1973 - 1974 Corvette: Service Bulletin: Engine Overheat Due to Blocked Coolant Passage in the Cylinder Head

Source: Chevrolet Dealer Service Technical Bulletin

Bulletin No: 74-T-6

Date: Dec. 5, 1973

TOP VIEW OF A CYLINDER HEAD PARTIALLY SECTIONED TO SHOW BLOCKED COOLANT PASSAGES

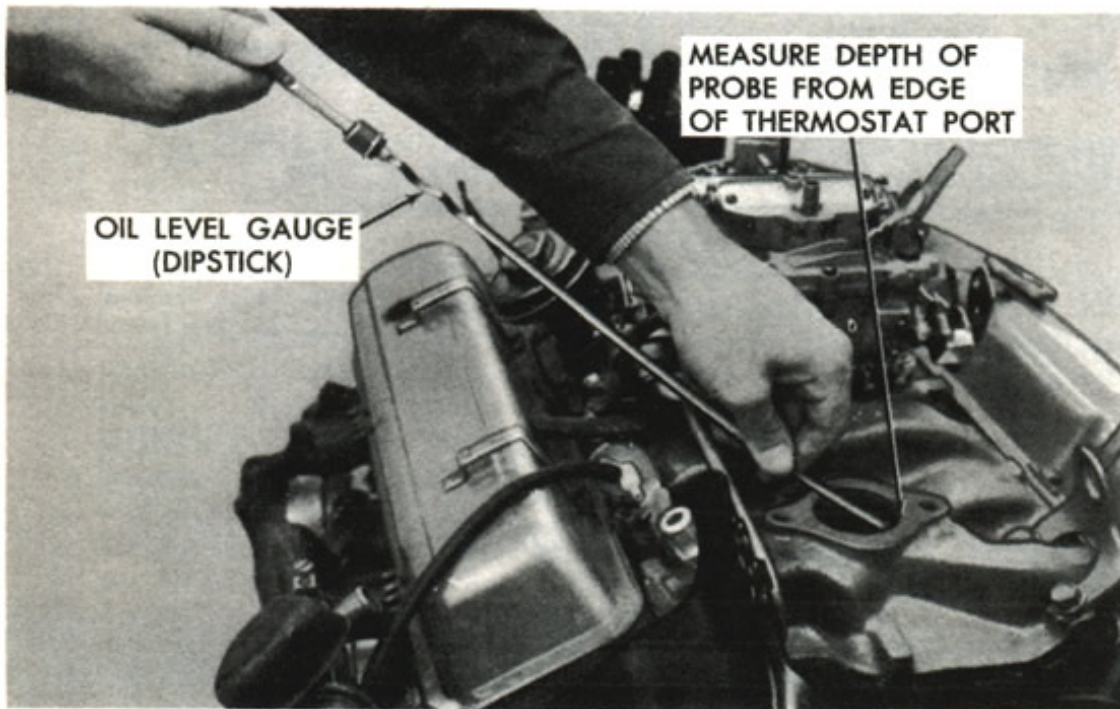
A small number of 350 and 400 cubic inch displacement V-8 engines were built before 9/24/73 (0924) with a coolant blockage in the cylinder head resulting in an overheat condition. A 1974 casting process change has resulted in a possible blockage of the coolant exit port in cylinder head casting No. 333882 (casting number appears on the top of the cylinder head beneath the rocker cover). This cylinder head is common to all 1974 small block V-8 engines, except for those used in C-K30 and 50 thru 60 series trucks.

6. If a blockage is present, it will occur at a depth of approximately five and one half (5-1/2) to six (6) inches from the edge of the thermostat port.

7. The blocked coolant port can be repaired by removing the inlet manifold and knocking out the casting flash in the blocked water passage with a suitable tool. Take care not to damage the oil drain boss. The particles of flashing that fall into the water jacket do not have to be removed. If the blockage cannot be removed, the cylinder head should be replaced.

1. Remove the thermostat housing and thermostat.
2. Insert the oil level gauge (dipstick) into the thermostat port thru the inlet manifold coolant passage and into the cylinder head (refer to the illustration on page 3).

3. Work the dipstick into the cylinder head as far as possible by carefully rotating and pushing the handle with one hand while guiding the blade with the other hand.

4. If at least seven (7) inches of the dipstick is inserted past the edge of the thermostat port, there is no blockage.
5. Remove the dipstick and repeat the test for the other cylinder head.
